CERTIFICATE OF APPROPRIATENESS

Property: 915 Harvard, Lot 9, Tract B, Block 230, Houston Heights Subdivision. The property includes a 2,476 square foot one and a half story residence with non-historic detached garage situated on a 6,600 square foot interior lot.

Proposal: Alteration – Replace Front Door and windows on noncontributing garage

RENDERING OF PROPOSED DOOR REPLACEMENT *proposal revised 9/7/22

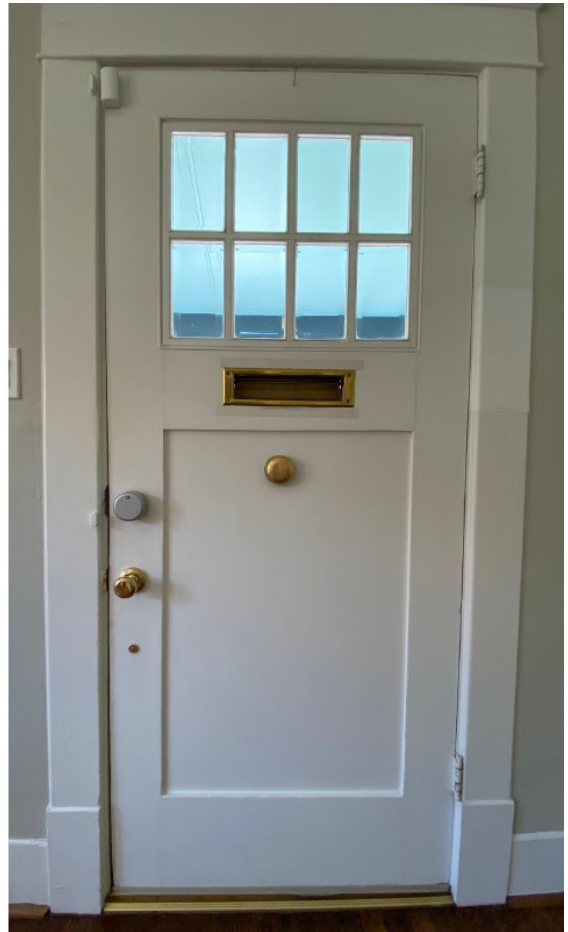
<i>The proposed door is reflective of a craftsman style, appropriate for the era of this home.</i> |

The proposed door is reflective of a craftsman style, appropriate for the era of this home.

GARAGE

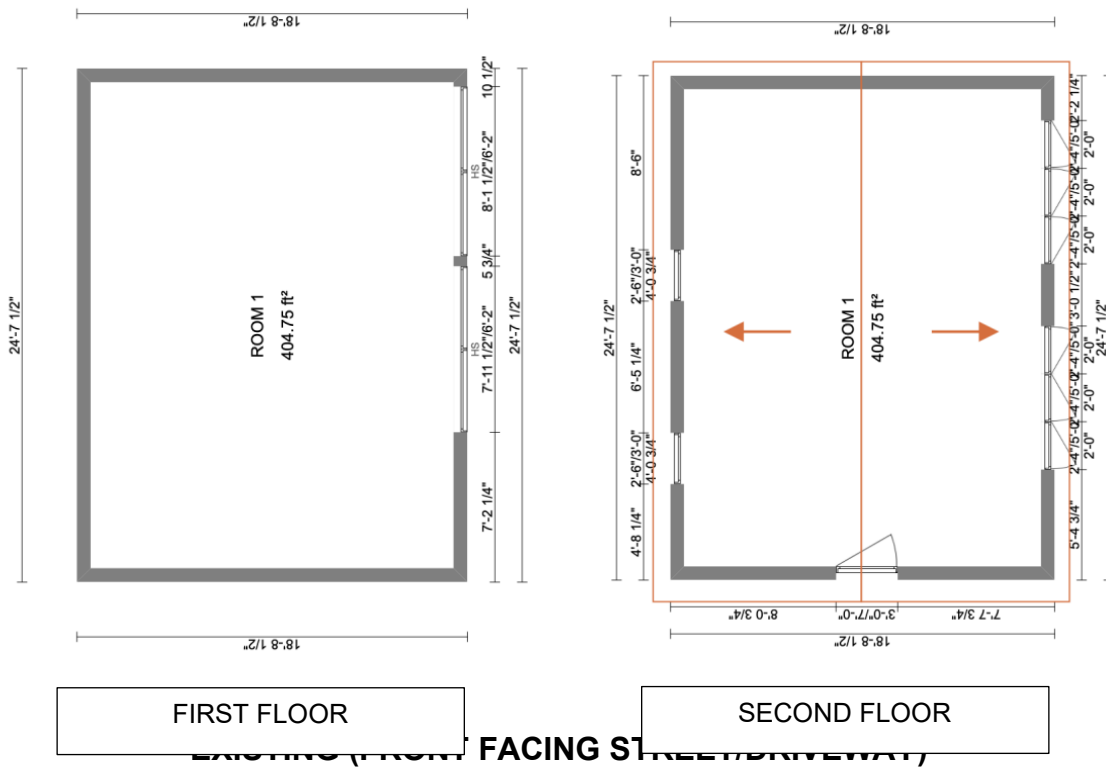
G10-REMOVE OPENING COMPLETELY

ENLARGE OPENINGS & REPLACE
